Proposals for amendments to Regulation No. 63

This informal document was prepared by the expert from the European Commission to complement the proposals in ECE/TRANS/WP.29/GRB/2016/7. **It contains additional amendments related to powered cycles. The amendments are related to the scope and to Annexes 3 and 4.**

Regulation No. 63 amend to read

Figure 1: Measuring positions for vehicles in motion

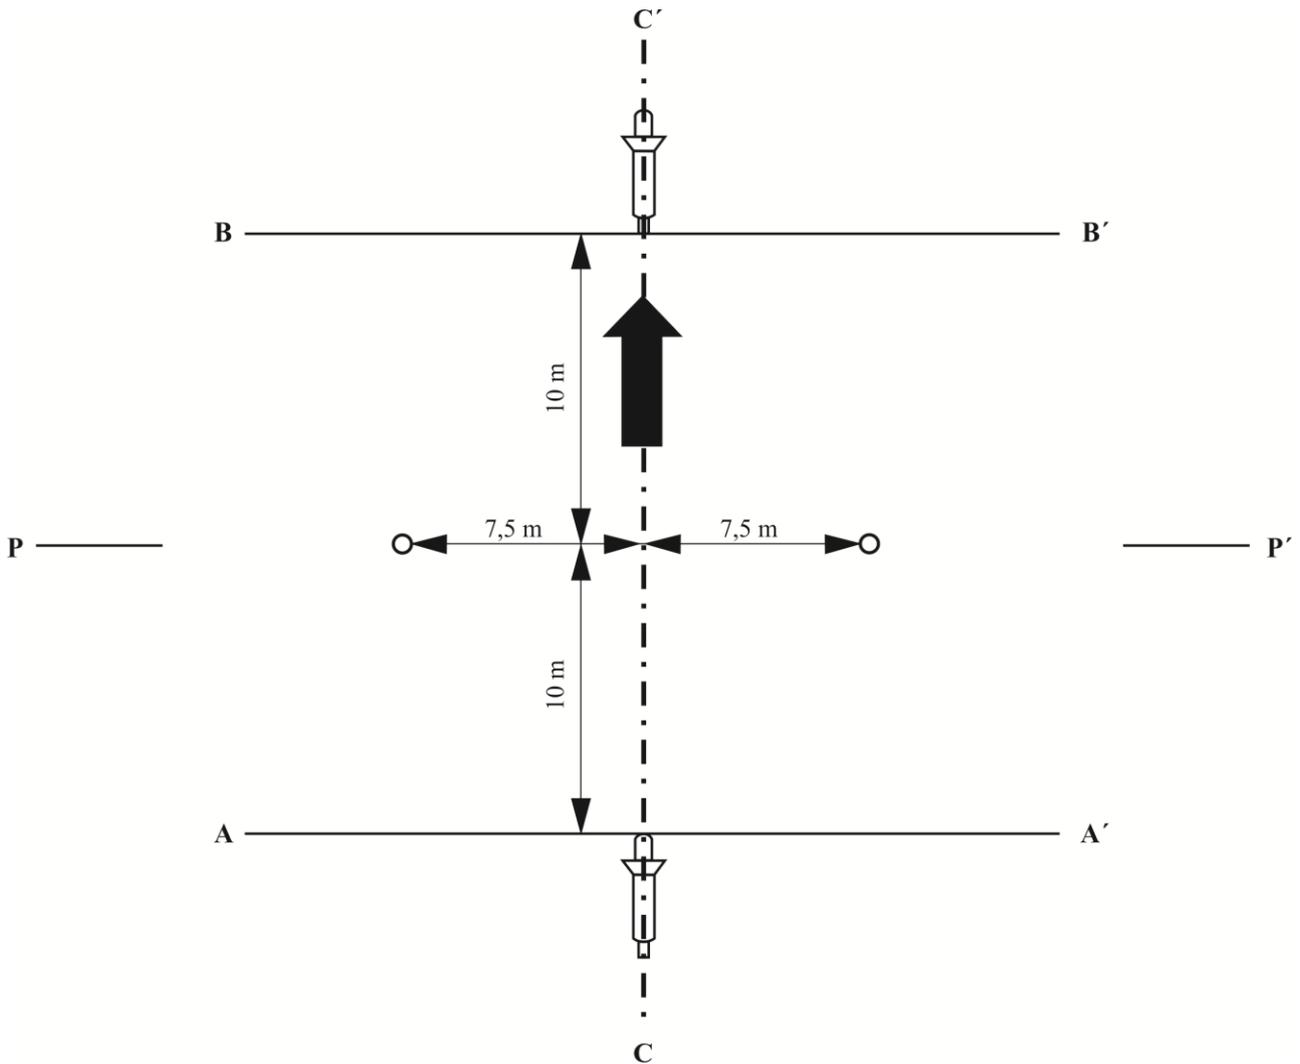
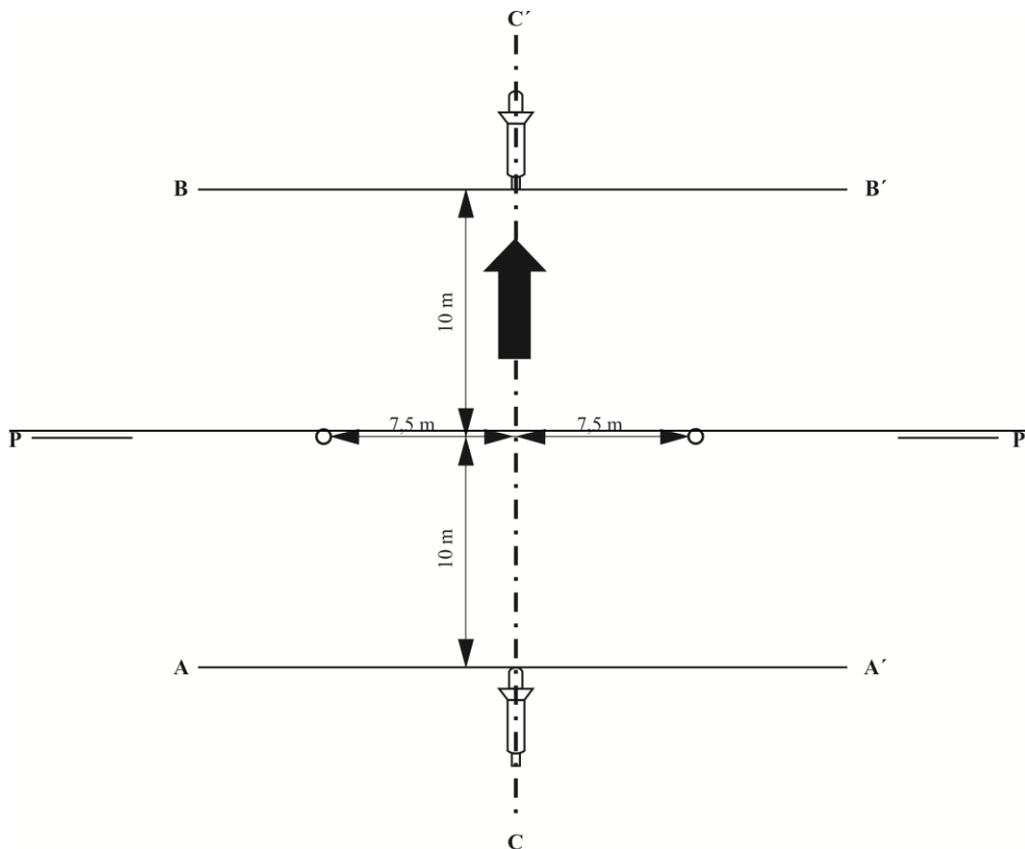
3.1.1.1. **The test arrangement is shown in figure 1.**

The header 3.1.1 “General conditions of test” was replaced by “Test arrangement and microphone positions”. Figure 1 was moved from the current position to this paragraph.

Figure 2: Measuring positions for the measurement of sound of the stationary vehicles

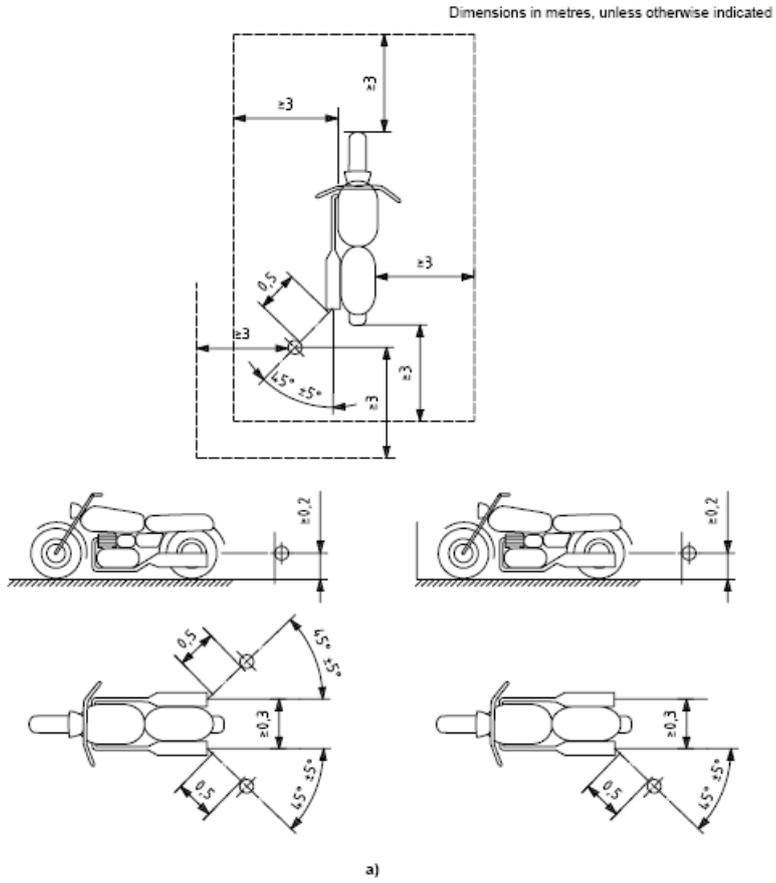
3.2.3.3.1. Position of the microphone (see figure 2)

Figures 2 and 4 were moved from the current positions to this paragraph, because they belong to this paragraph. Figure 4 was renamed to figure 3 in order to ensure the right rank order.

Figure 3: Reference point

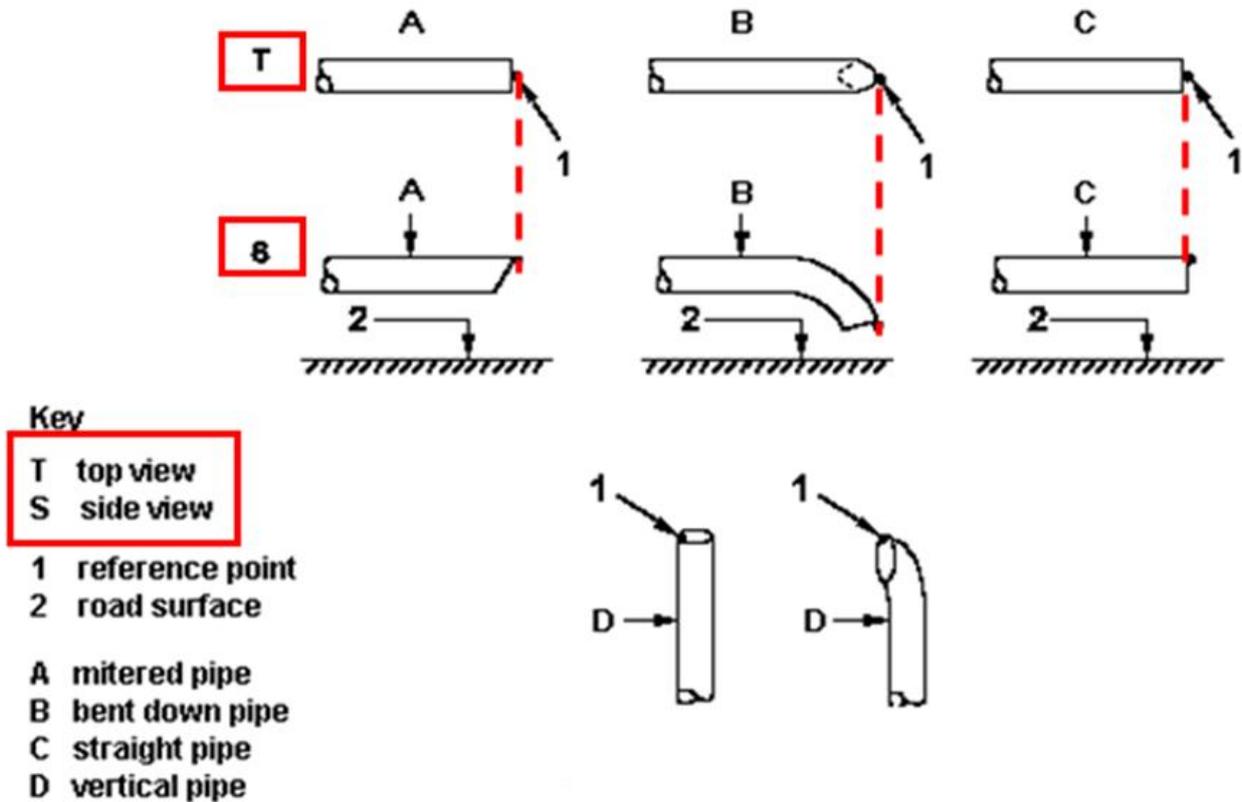
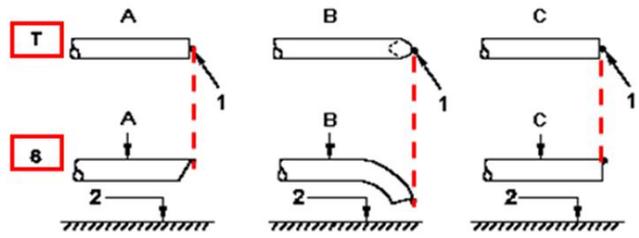
The microphone shall be located at a distance of 0.5 ± 0.01 m from the reference point of the exhaust pipe defined in ~~figure 4~~ figure 3 and at an angle of $45^\circ \pm 5^\circ$ to the vertical plane containing the flow axis of the pipe termination. The microphone shall be at the height of the reference point, but not less than 0.2 m from the ground surface. The reference axis of the microphone shall lie in a plane parallel to the ground surface and shall be directed towards the reference point on the exhaust outlet.

Figure 4: Test apparatus for conditioning by pulsation

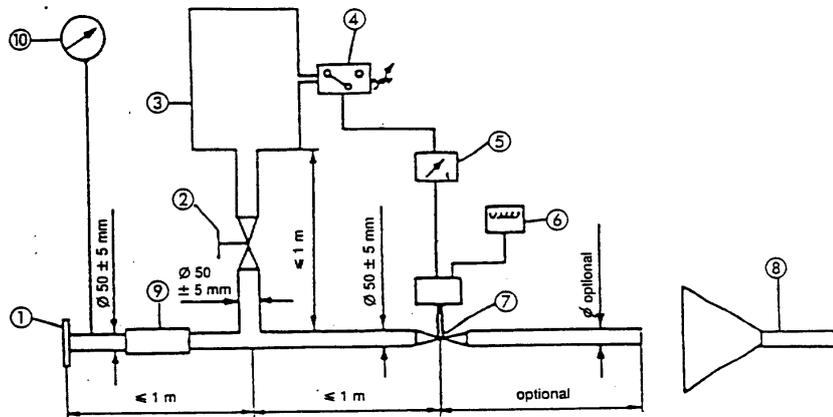
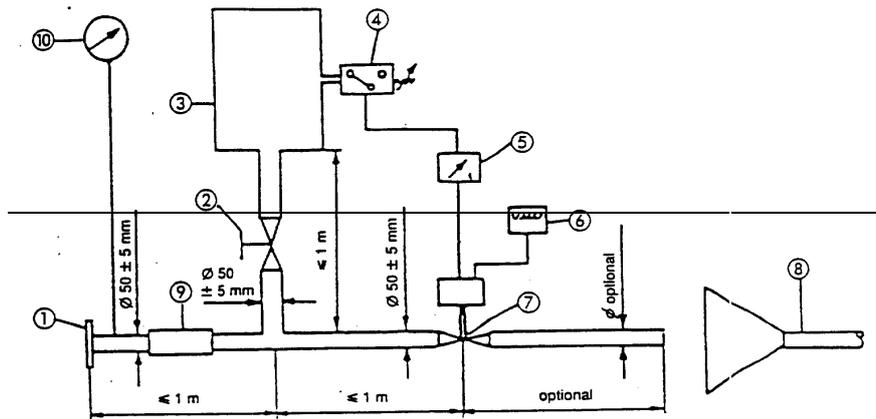
- The test apparatus, a detailed diagram of which is shown in ~~Figure 3~~ **figure 4**, shall be fitted at the outlet of the exhaust system. Any other apparatus providing equivalent results shall be acceptable.

Figure 3 was moved from paragraph 5.3 to this paragraph, where it belongs to and was renamed to figure 4 in order to ensure the right rank order.
